DESIGN UP	DRAWN BY UP	DART AEROSPACE LTD HAWKESBURY, ONTARIO, CANADA	
CHECKED #	APPROVED #	DRAWING NO. DSI 9053	REV. B SHEET 1 OF 2
DATE 01.04.16		TITLE BASKET HINGE CHANGE	SCALE NTS
A	96.11.06	NEW ISSUE	
B	01.04.16	REDRAWN

DART SERVICE INSTRUCTION

TO AMEND INSTALLATION DRAWING D205-541 REV. D
(REF. CANADIAN STC: SH96-120, FAA STC: SR00696NY)
AND INSTALLATION DRAWING D350-607 REV. E
(REF. CANADIAN STC: SH94-14, FAA STC: SR00213NY)

DESIGN <i>CP</i>	DRAWN BY <i>CP</i>	DART AEROSPACE LTD HAWKESBURY, ONTARIO, CANADA	
CHECKED <i>A</i>	APPROVED <i>A</i>	DRAWING NO. DSI 9053	REV. B SHEET 2 OF 2
DATE 01.04.16	TITLE BASKET HINGE CHANGE		SCALE NTS

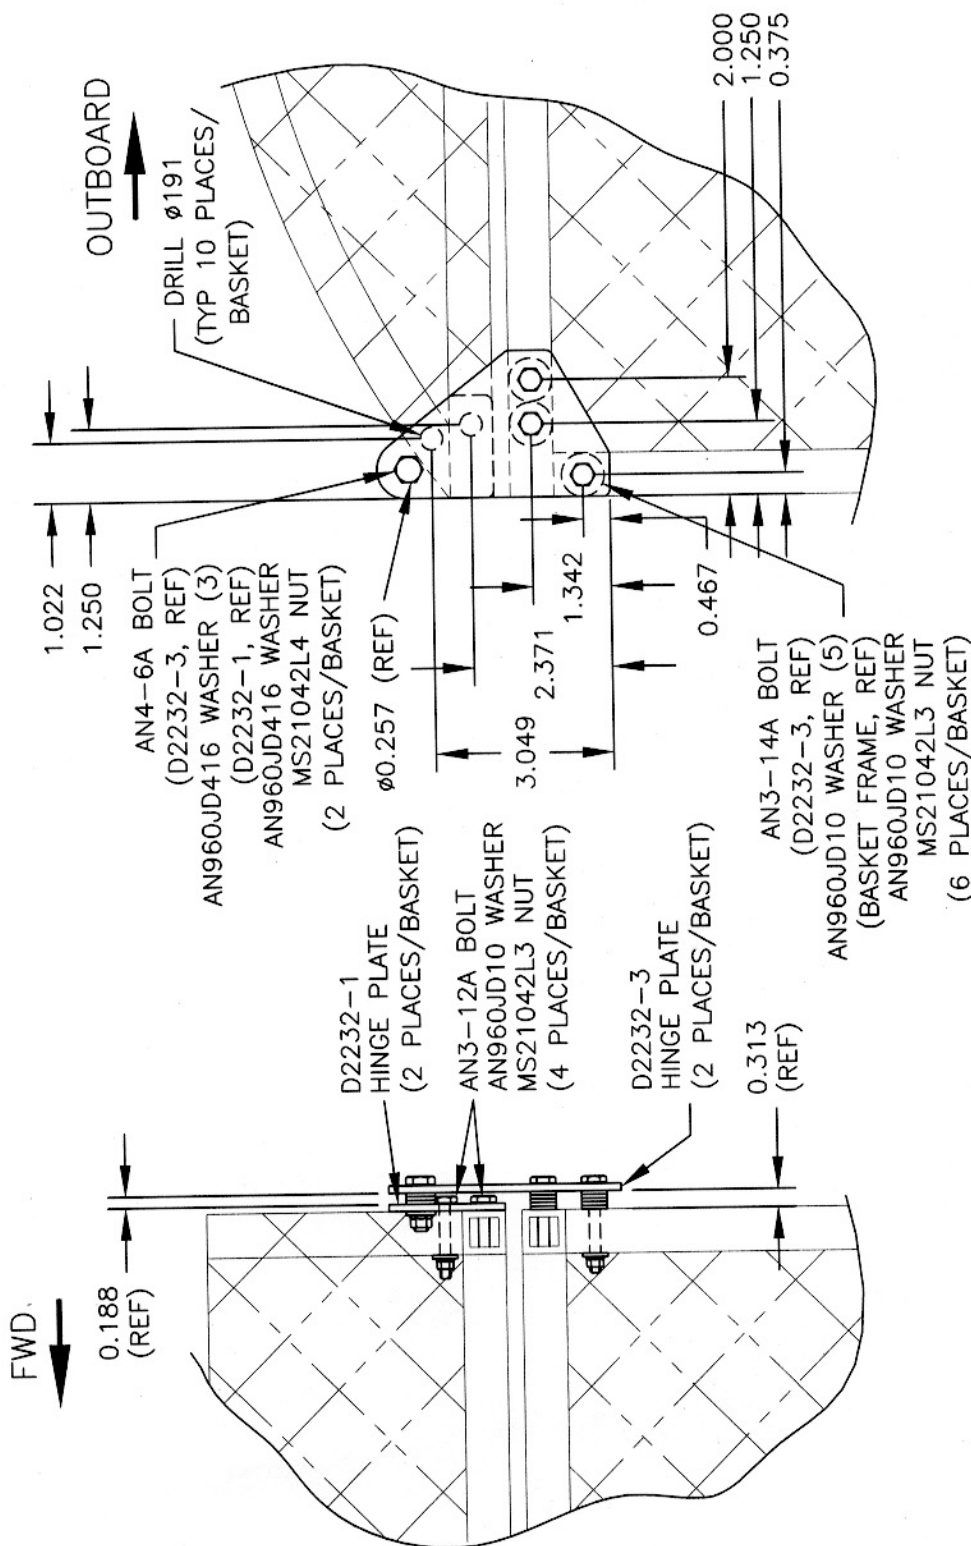
IF THE D2569 HINGE IS BEING REPLACED, THE PARTS LIST OF D205-541 REV. D (D205-541-011 CHG 003) / D350-607 REV. E (D350-607-041/-042 CHG 004) SHOULD BE AMENDED AS FOLLOWS:

REPLACE D2569 HINGE AS FOLLOWS:

- 1) REMOVE EXISTING HINGE BY DRILLING OUT AD64ABSLF RIVETS. PLUG HOLES WITH RIVETS IF DESIRED.
- 2) DRILL HOLES IN D2232-1/-3 HINGE PLATES AS SHOWN ON PAGE 2.
- 3) LOCATE D2232-1 HINGE PLATE ON D2512 BASKET LID ASSEMBLY. REMOVE MESH AS REQUIRED SO THAT D2232-1 HINGE PLATE SITS FLUSH ON D2512 BASKET LID ASSEMBLY. TRANSFER DRILL Ø0.191 HOLES. INSTALL D2232-1 HINGE PLATE WITH HARDWARE AS SHOWN ON PAGE 2. REPEAT AT OTHER END OF BASKET.
- 4) LOCATE POSITION OF D2232-3 HINGE PLATE FROM D2232-1 HINGE PLATE BY ENSURING Ø0.257 HOLE IS ALIGNED. REMOVE MESH AS REQUIRED TO ENSURE THAT D2232-3 HINGE PLATE AND ATTACHMENT HARDWARE SITS FLUSH AGAINST D2206/D2221 BASKET BASE ASSEMBLY. TRANSFER DRILL Ø0.191 HOLES. INSTALL D2232-3 HINGE PLATE WITH HARDWARE AS SHOWN ON PAGE 2. REPEAT AT OTHER END OF BASKET.
- 5) TOUCH UP PAINT AS REQUIRED.

Qty	Part Number	Description
X	DSI 9053-011	HINGE CHANGE KIT
2	D2232-1	HINGE PLATE
2	D2232-3	HINGE PLATE
4	AN3-12A	BOLT
6	AN3-14A	BOLT
2	AN4-6A	BOLT
40	AN960JD10	WASHER*
8	AN960JD416	WASHER*
10	MS21042L3	NUT (OR MS21042-3)
2	MS21042L4	NUT (OR MS21042-4)

* NOTE: IT IS ALSO ACCEPTABLE TO REPLACE THE WASHERS THAT ARE USED AS SPACERS WITH A SINGLE ALUMINUM SPACER OF APPROPRIATE LENGTH (SEE PAGE 2).
